BEV SMITH KIA NEW DEALERSHIP
PROJECT NARRATIVE

The applicant has an existing site of 9.63 acres located at 5560 South U.S Highway 1 in Fort Pierce, Florida. The improvements include constructing a new 40,791 sf Kia automobile dealership building with associated parking lot for inventory. Stormwater management facilities, water, sewer, lighting and landscaping improvements are also planned. Demolition of the existing automotive care center along with it's parking areas is planned. The site is comprised of one parcel and therefore a Unity of Title will not be required to construct the proposed improvements.

SITE PLAN

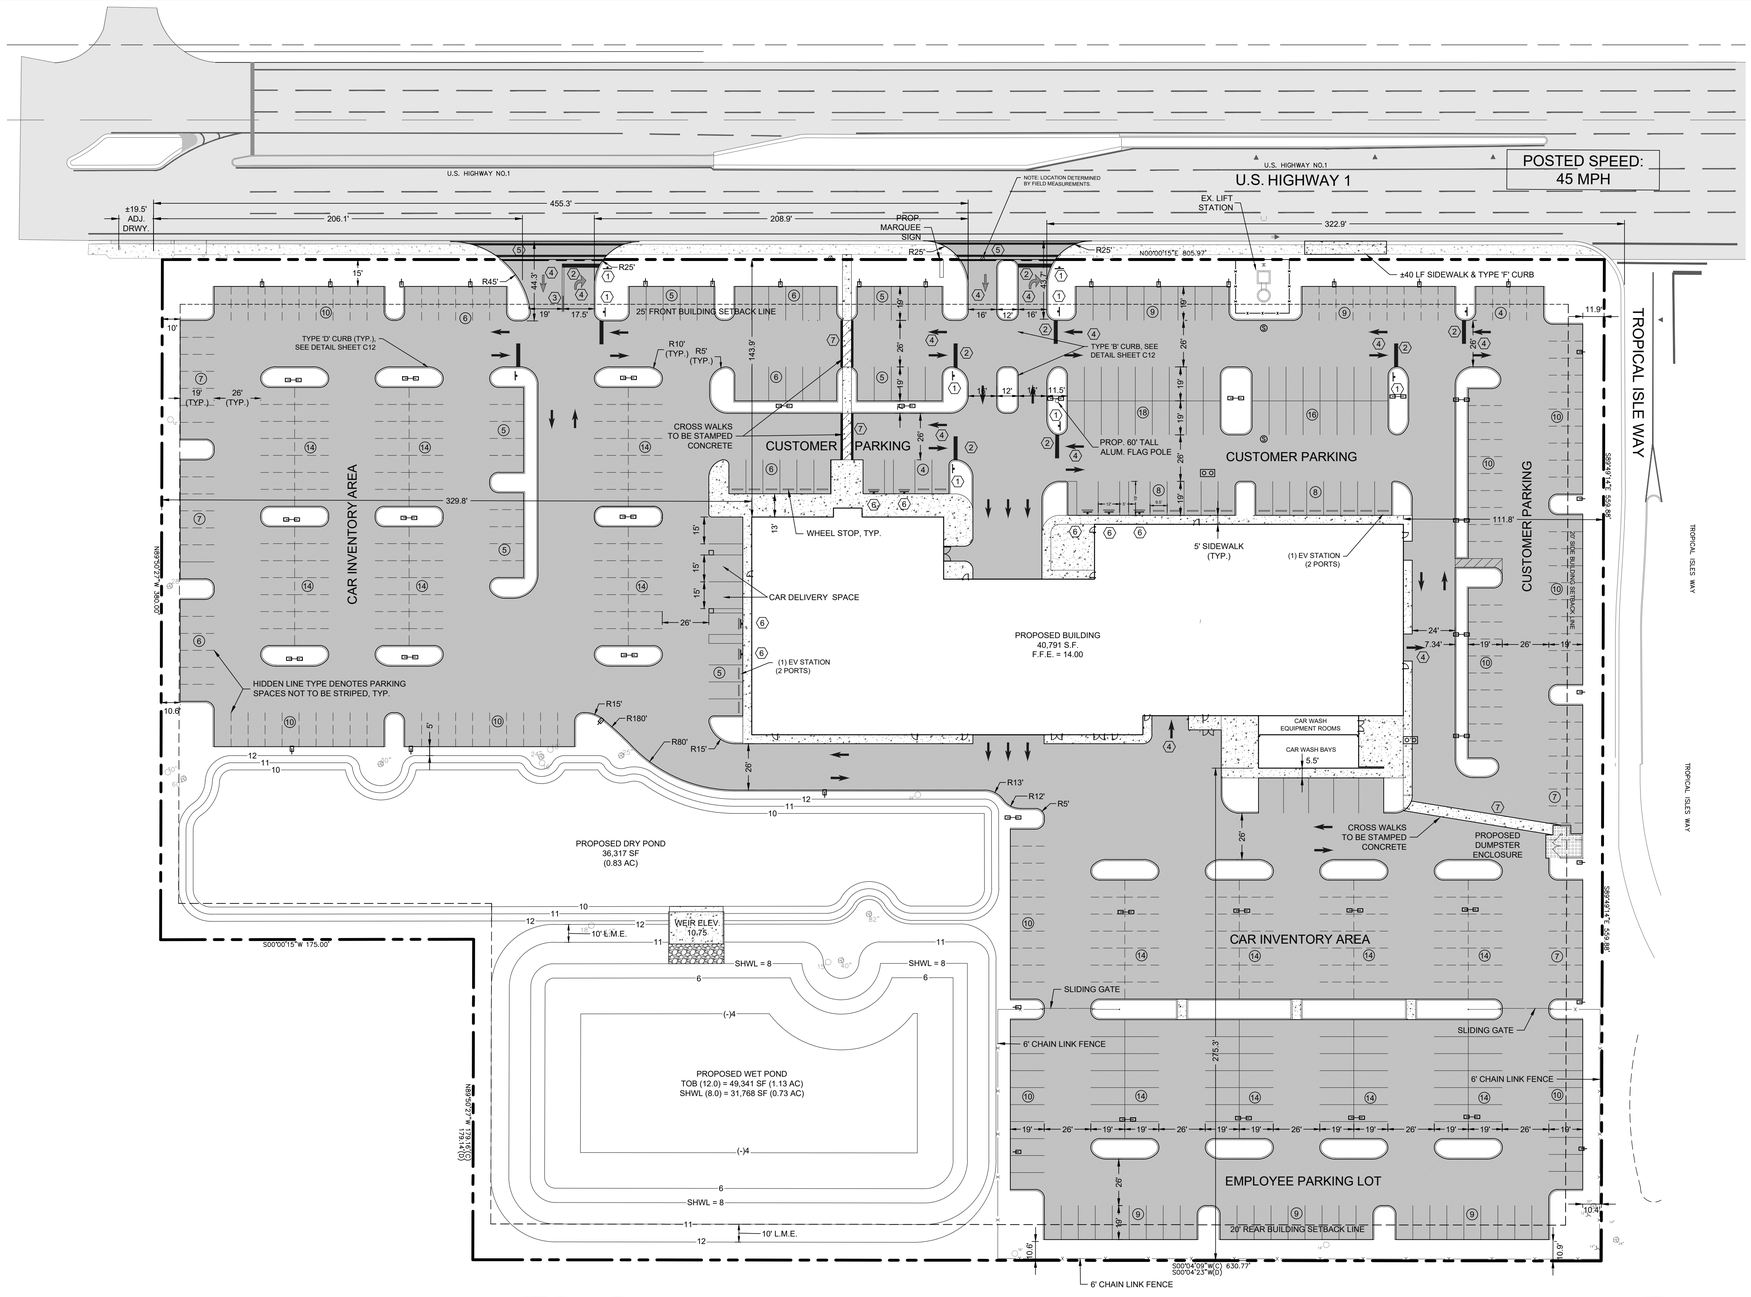
2. Update site plan to reflect distance between entrance (drive) ways, according to city code Access Control Sec. 125-316(b)(2). **See Site Plan, sheet C6, for dimensions of access driveways.**

6. The site plan notes a monument (MON) page C5. Please identify what the monument is and where the monument will be located. **Please refer to the Site Plan, sheet C6, for the location of the monument sign and its callout.**

5. Identify proposed sidewalk width. **See sidewalk dimensions as listed on the Site Plan, sheet C6.**

7. Show width of parking spaces. **See Site Plans, sheet C6, for dimensions of parking spaces.**

DRAINAGE STRUCTURE SCHEDULE

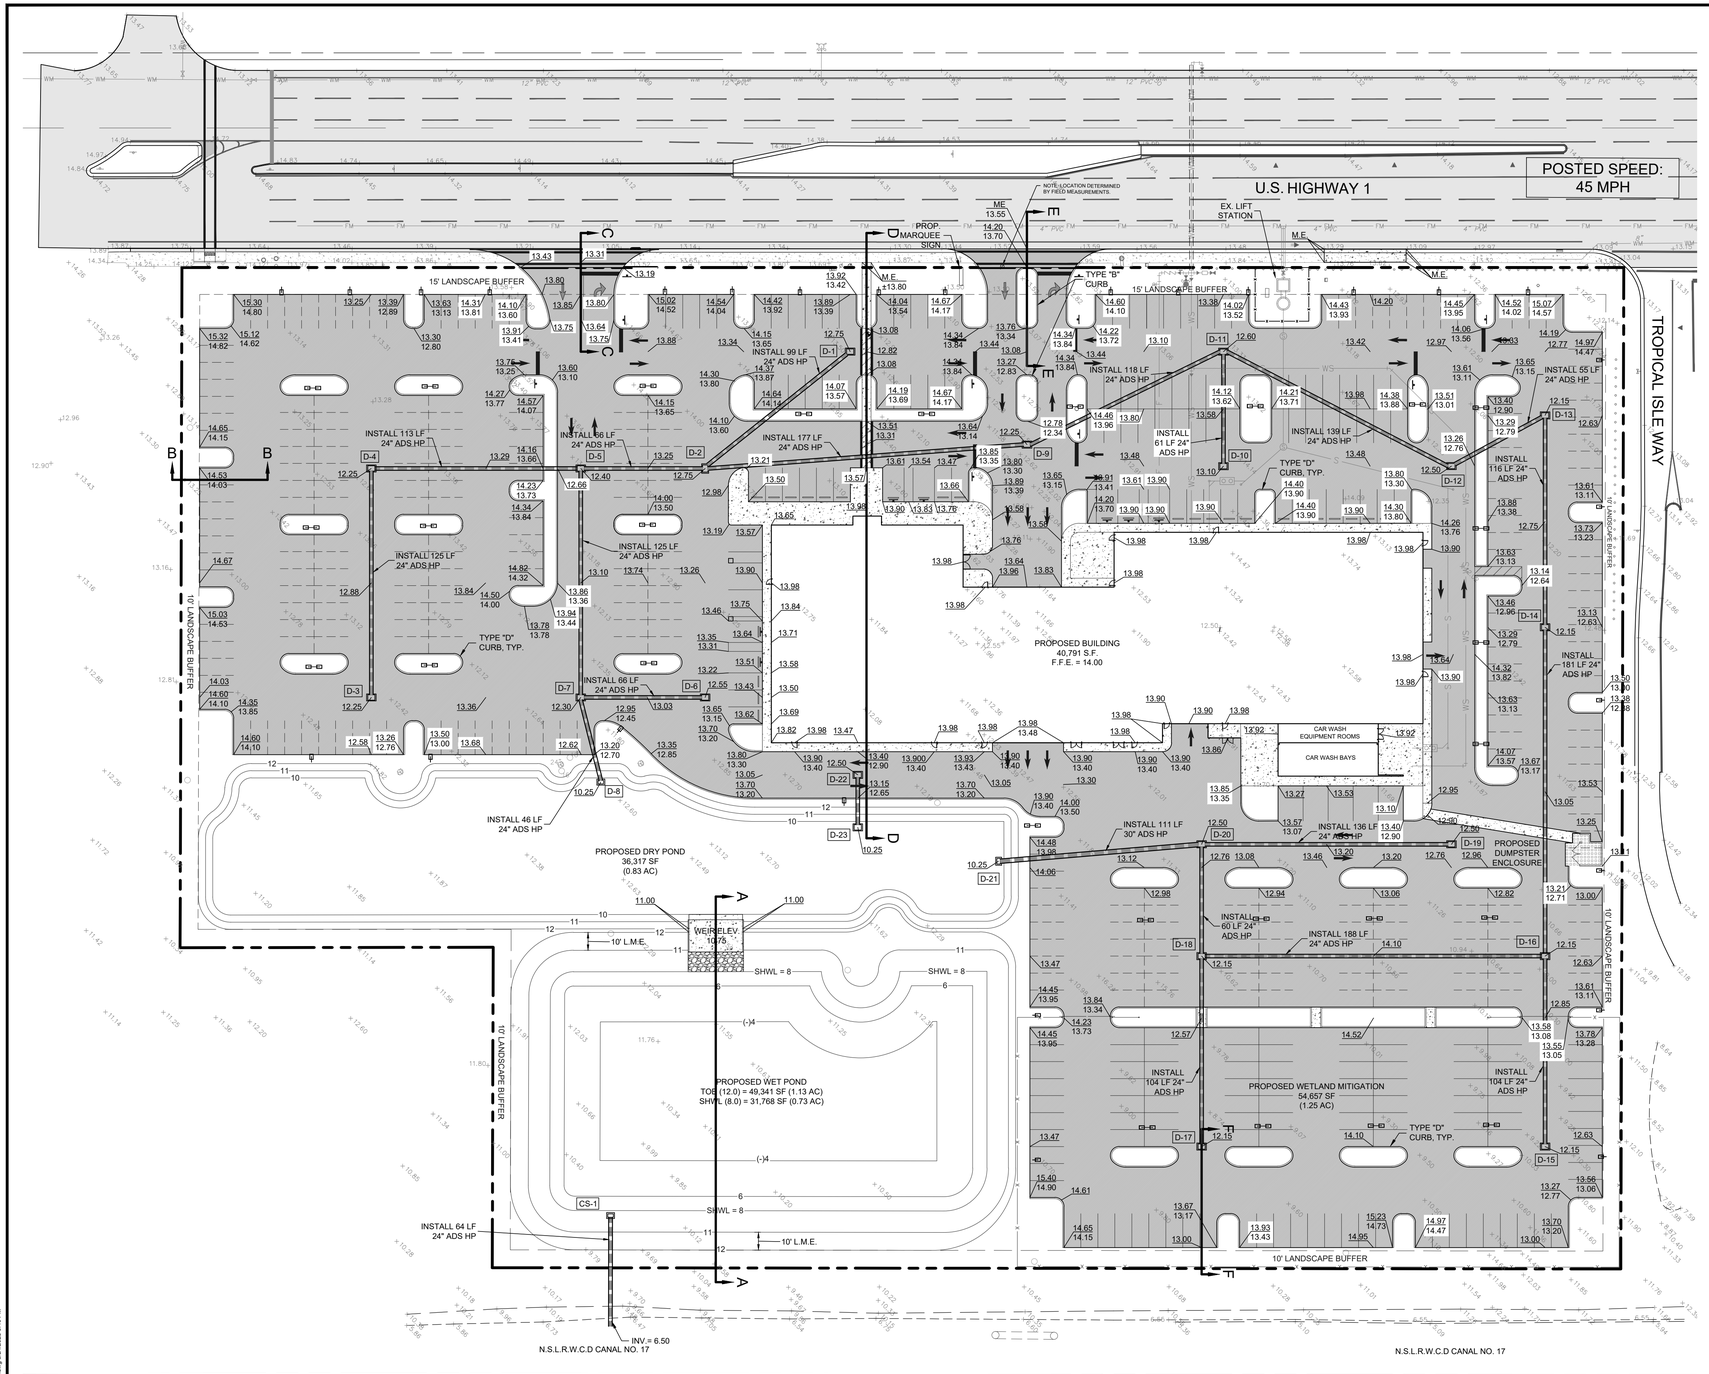
4. Add a note indicating that all storm drainage facilities shall conform to chapters 32 and 121 and the Standard Specifications adopted by the city commission on February 13, 1973, as amended. **See Note on the PGD plan, sheet C7 of the plans.**

FIRE PROTECTION PLAN

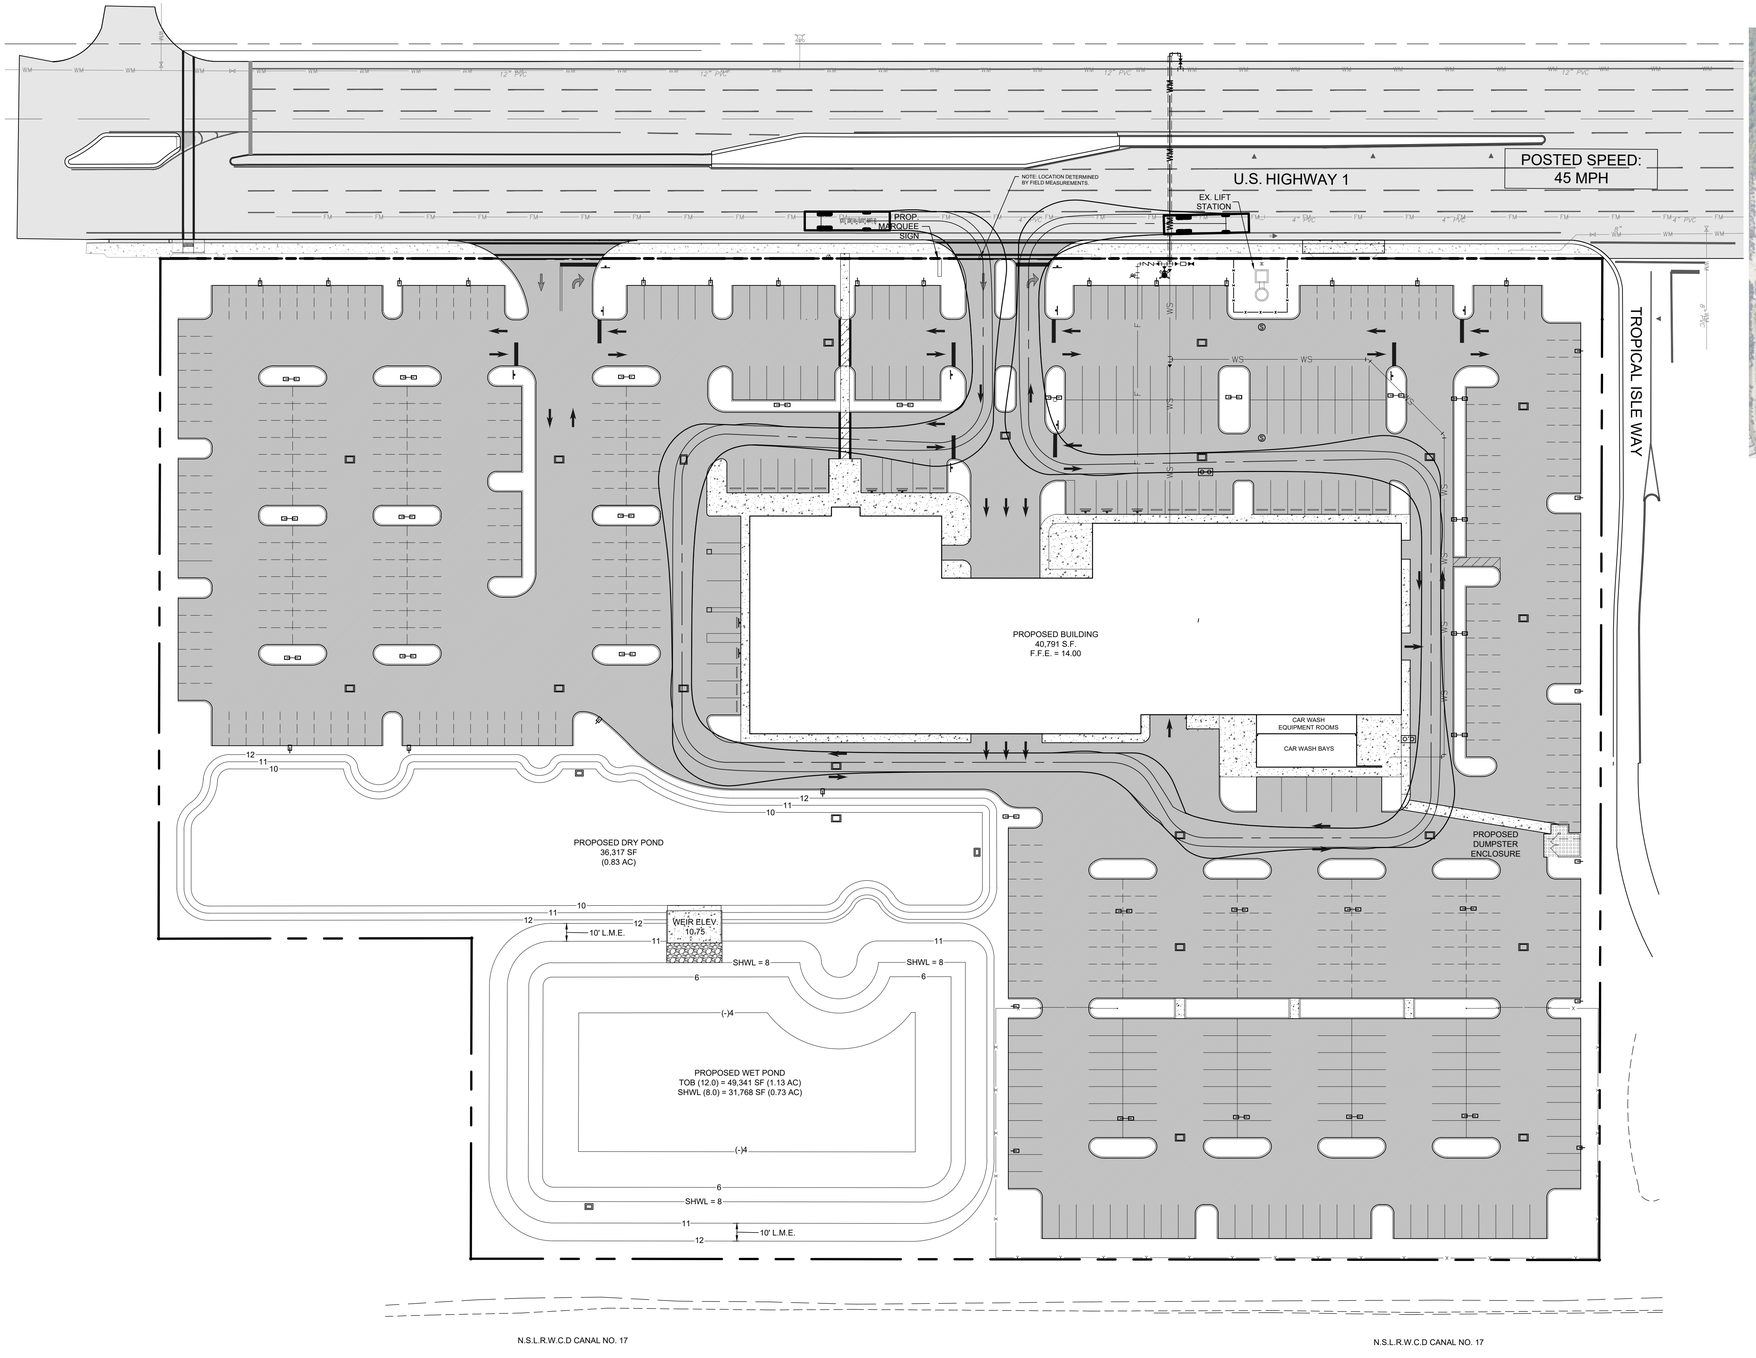
12. Be advised: Dimensions of largest vehicle are as follows: 38 tons or 77,000 lbs, 47.5 ft. total length, 21.5 ft. wheel base, 10.5 ft. total width, 41.5 degree turning radius. **Acknowledged, please refer to the Fire Protection Plan, on sheet C10, which shows the turning movements for this type of vehicle, around the site.**

26. Site Plans submitted in accordance with this Fire Prevention Code shall include the size, layout, and offsite connections for the water distribution system and the location of all existing and proposed fire hydrants within one thousand (1,000) feet of the proposed project. **See the Hydrant Spacing view on sheet C10 of plans.**

SITE PLAN

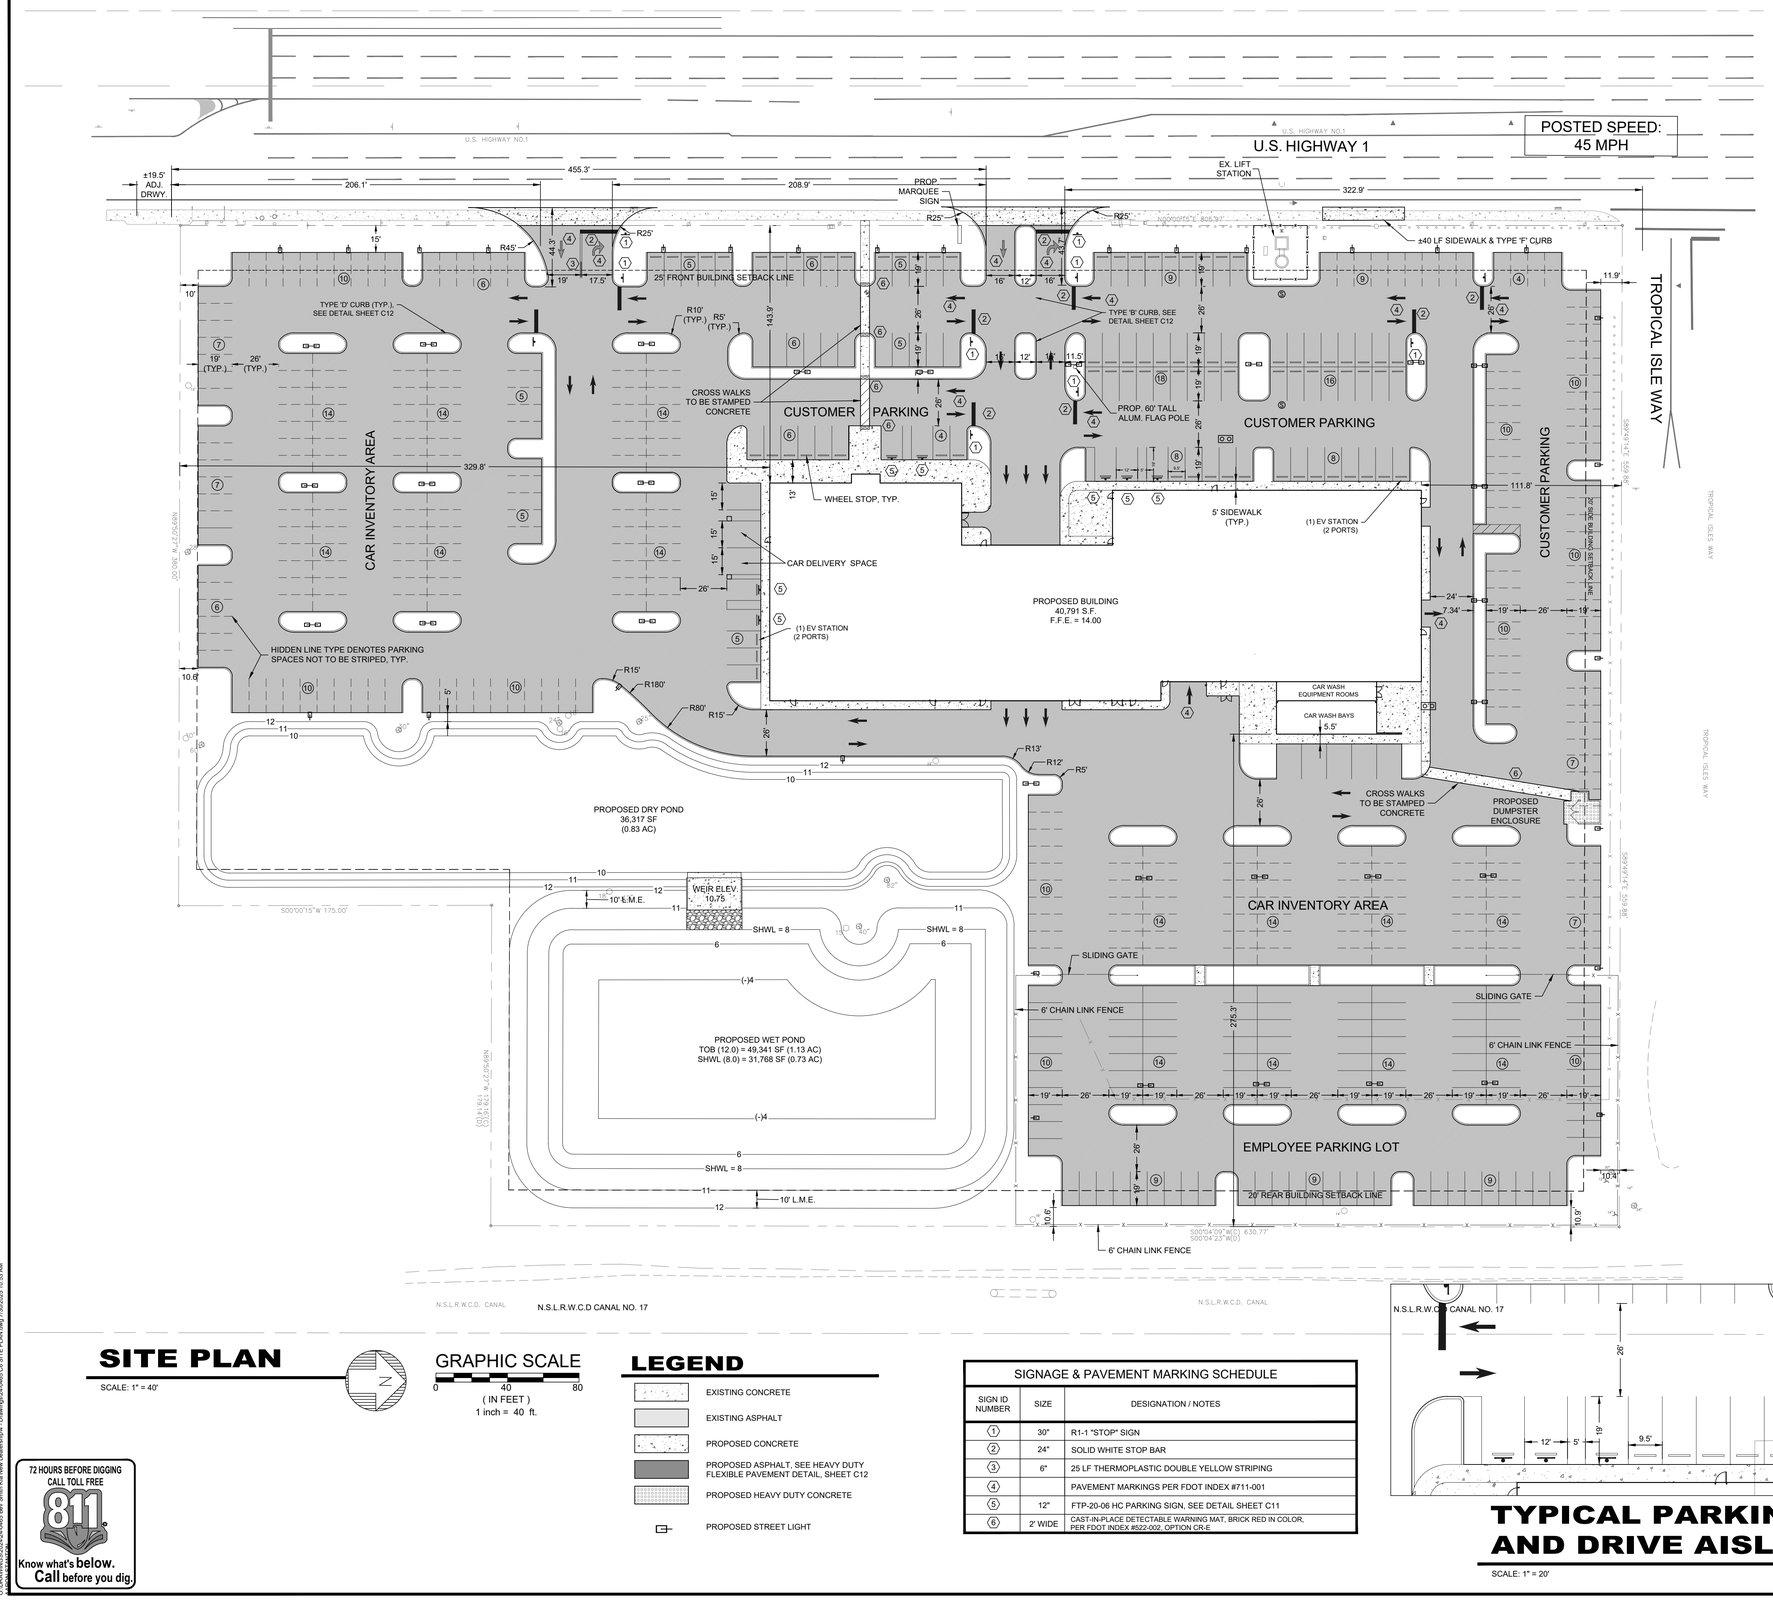
1. Plans do not show ADA ramps/detectable warning surfaces, no details provided for ramps or detectable warning surfaces. **Please see sheet C6 for revised plans showing detectable warning surfaces at the curb ramps at the pedestrian crossing.**
